Submissions Report

AGL Dalton Power Project

APRIL 2012

Prepared for
NSW Department of Planning and Infrastructure
On behalf of
AGL Energy Limited
Level 22, 101 Miller Street
North Sydney, NSW 2064
43177661

Figure 3-1 Predicted 35dB(A) contours across Project Area and Surrounds

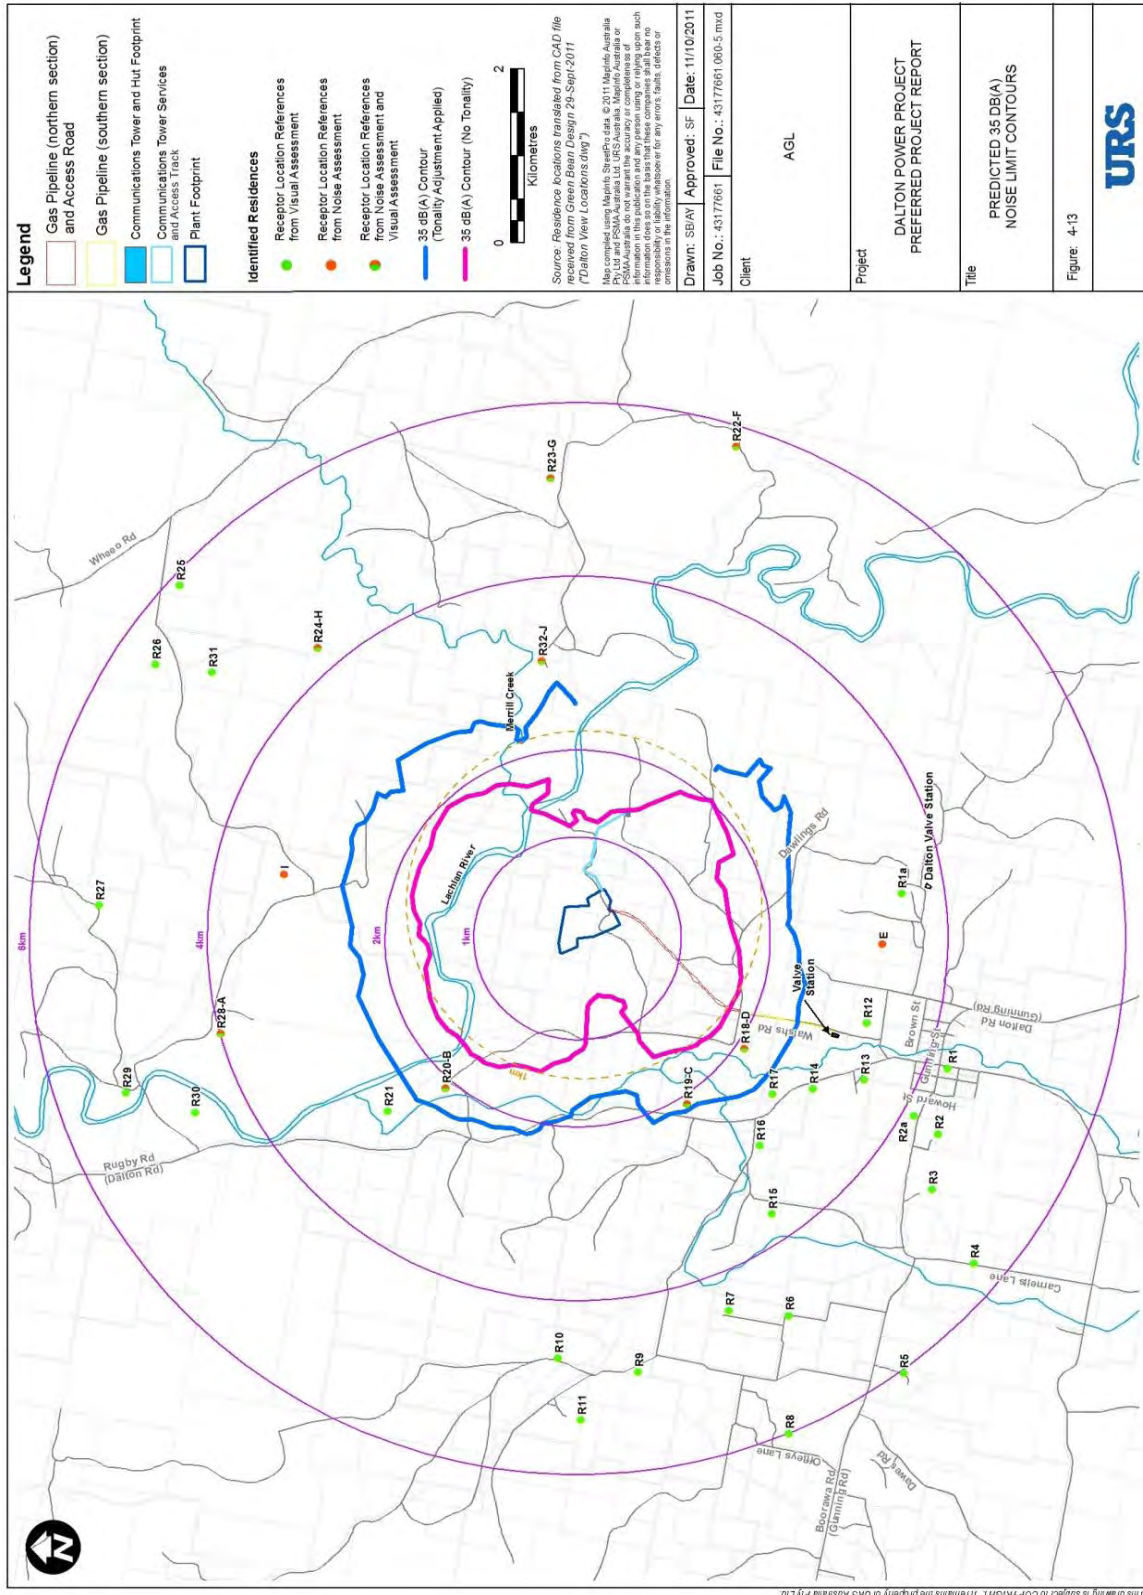
The noise assessment considered the closest receptors surrounding the proposed turbine locations. These are illustrated as locations A to J in the attached site plan. Also illustrated are the receptors considered by the visual assessment prepared by Green Bean Design.

The pink contour shown on the site plan indicates the L_{Aeq} 35 dB(A) noise limit without any adjustment for the occurrence of tonality; whereas the blue contour indicates the L_{Aeq} 35 dB(A) noise limit assuming tonal emissions from the site, as determined at the receptors.

The figure identifies that compliance with the L_{Aeq} 35 dB(A) noise limit is expected at receptors R21 and R12-17, even with consideration to the penalty that would be imposed for the occurrence of tonality.

Drawn: SB	Approved: HQ	Date: 13/10/2011
Job No.: 43177661	File No.: 43177661.078.mxd	
Client		
AGL		
Project		
DALTON POWER PROJECT PREFERRED PROJECT REPORT		
Title		
REFERRED PROJECT GAS PIPELINE (SOUTHERN PORTION) REVISED ROUTE & AREA OF ADDITIONAL INVESTIGATION		
Figure: 4-1		
URS

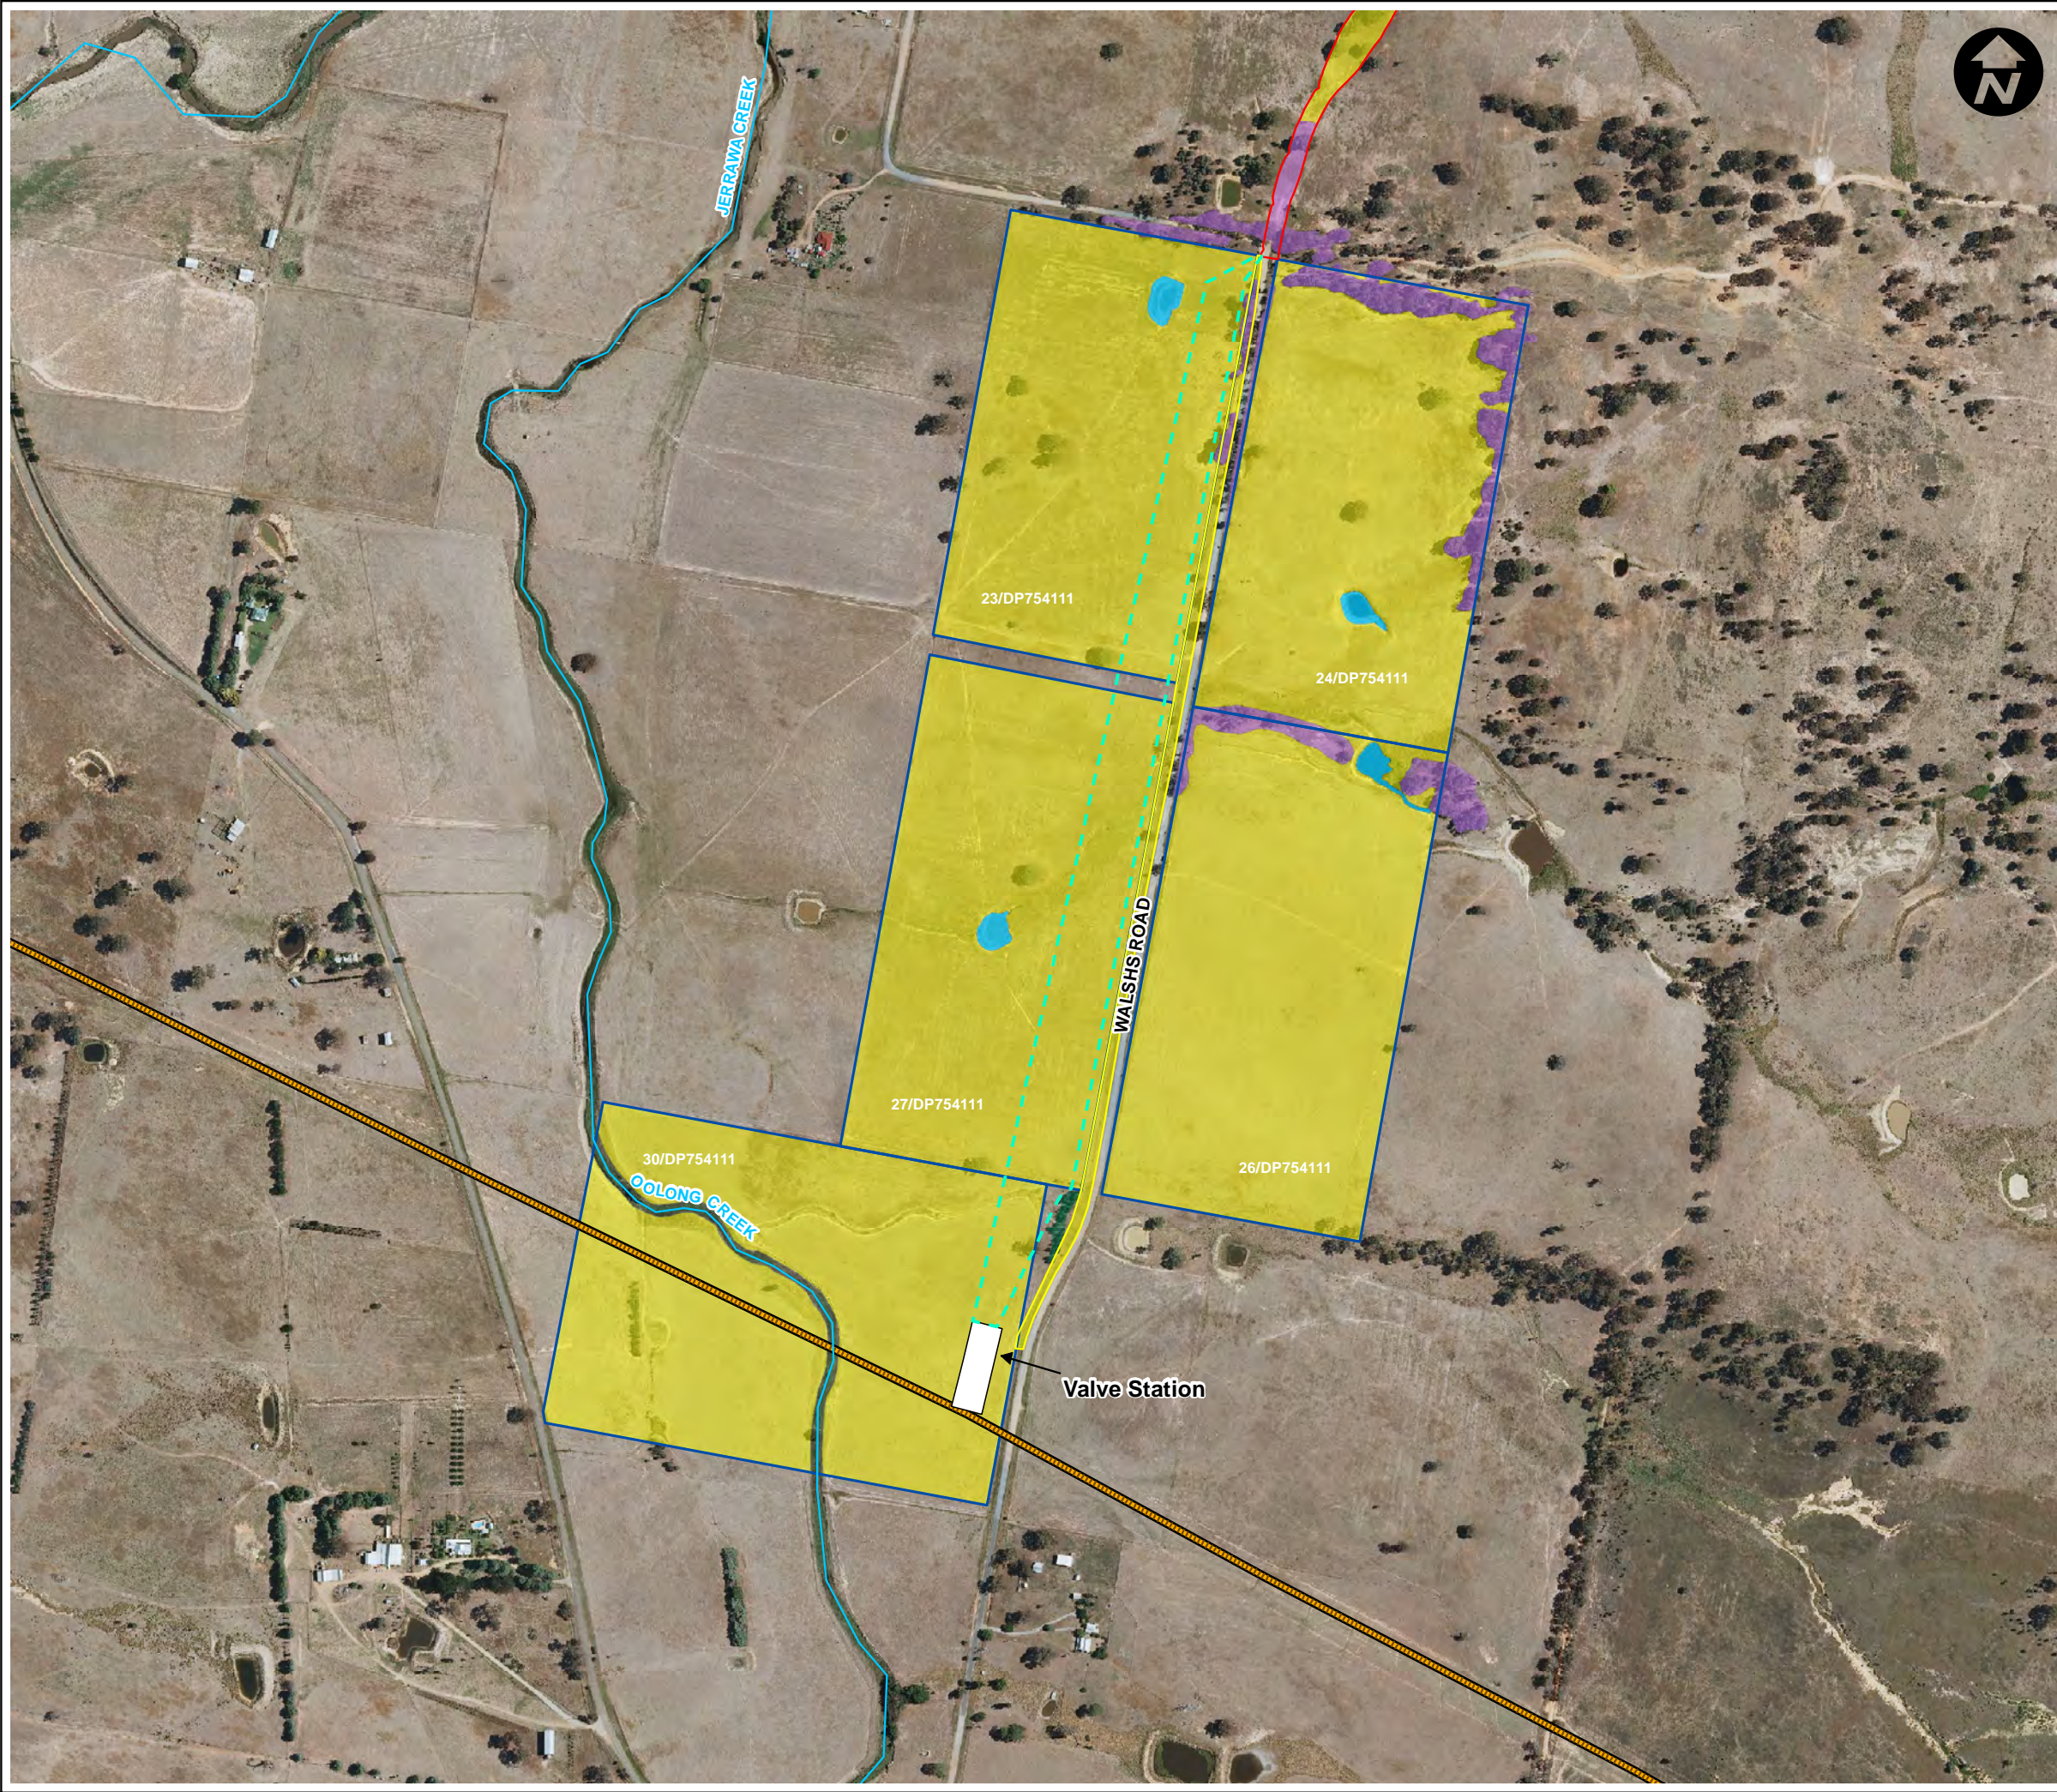
During consultation with AGL in August 2011 the Upper Lachlan Shire Council (ULSC) had indicated a preference for the Gas Pipeline (southern portion) to be sited outside of the road easement. This request was confirmed in the Submission received from the Upper Lachlan Shire Council in September 2011 (Submission 19969):

"The EA discusses that the pipeline would be constructed along Walsh's Rd, Unfortunately, the existence of approximately ten mature, protected white box and Blakely's Red Gum trees within the road reserve leave inadequate space for both the pipeline and the proposed widening of the road. If the pipeline was to be constructed underneath the road, extreme disruptions to traffic would occur for

duration of the construction work. The road reconstruction work would also become difficult as the pipeline would need to be buried at a significant depth to prevent damage to it by the anticipated heavy traffic.”

After these studies, AGL proposes to relocate the Gas Pipeline (southern portion) to a position west of the original proposal, as shown in **Figure 4-1 and 4-2**.

Figure 4-2 Heritage features in proximity to amended pipeline corridor

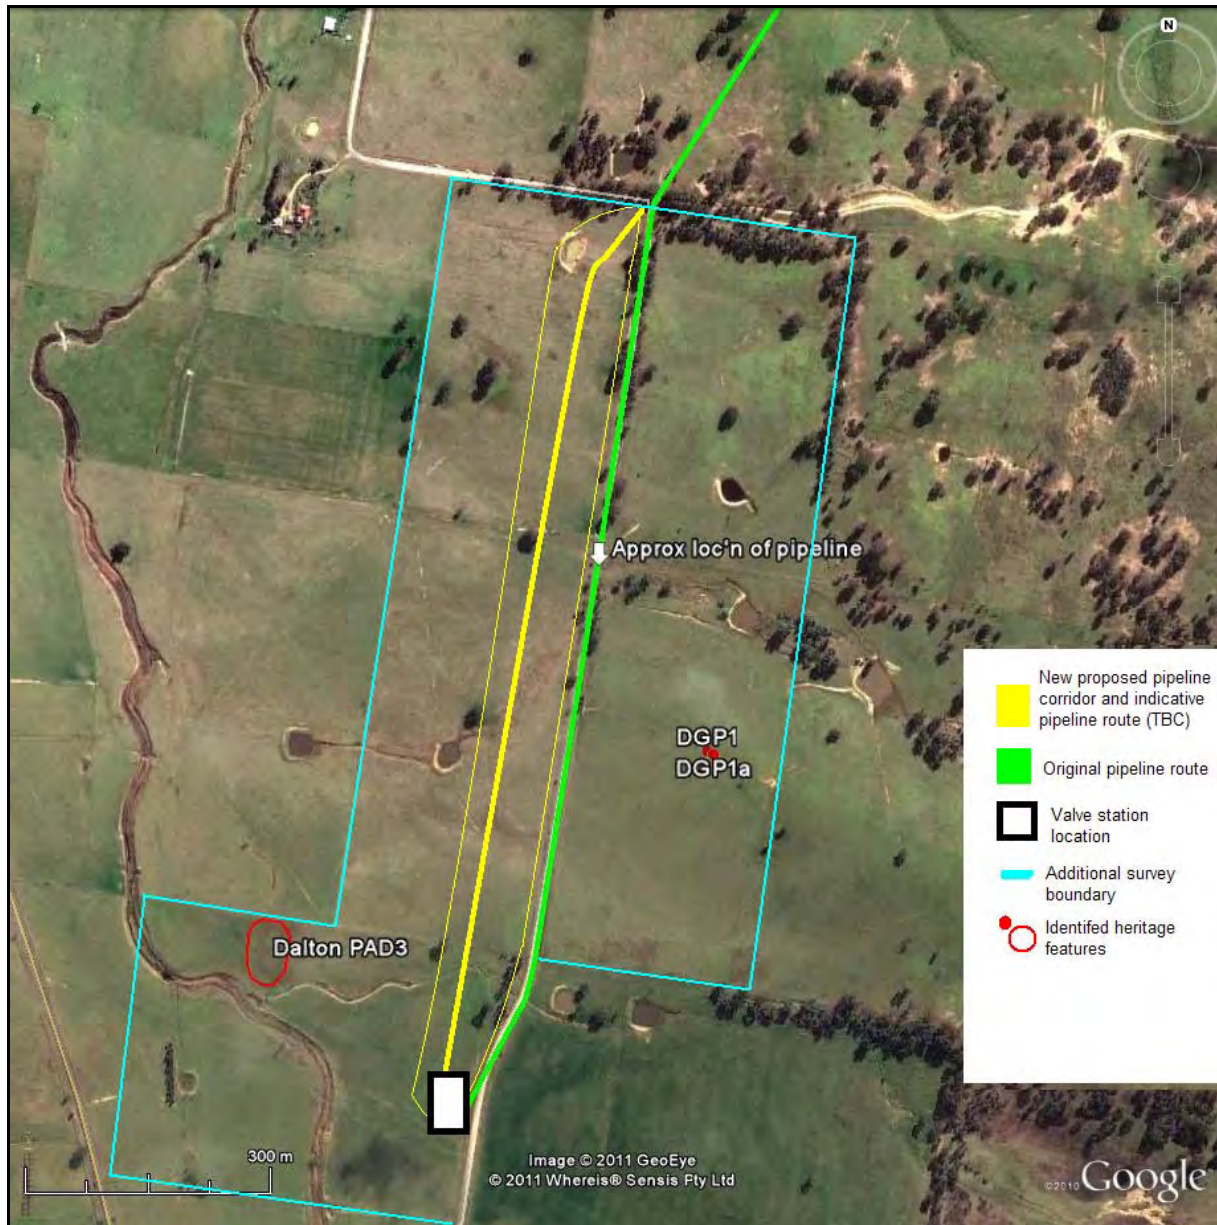
Navin Officer reported that while the artefact recorded at DGP1 (in Lot 26) was not re-found, another artefact was recorded about 10 m away from the original location (DGP1a). The location of these finds is shown in **Figure 4-2** below. This artefact is also located outside of any potential impact zone of a proposed realignment of the gas pipeline.
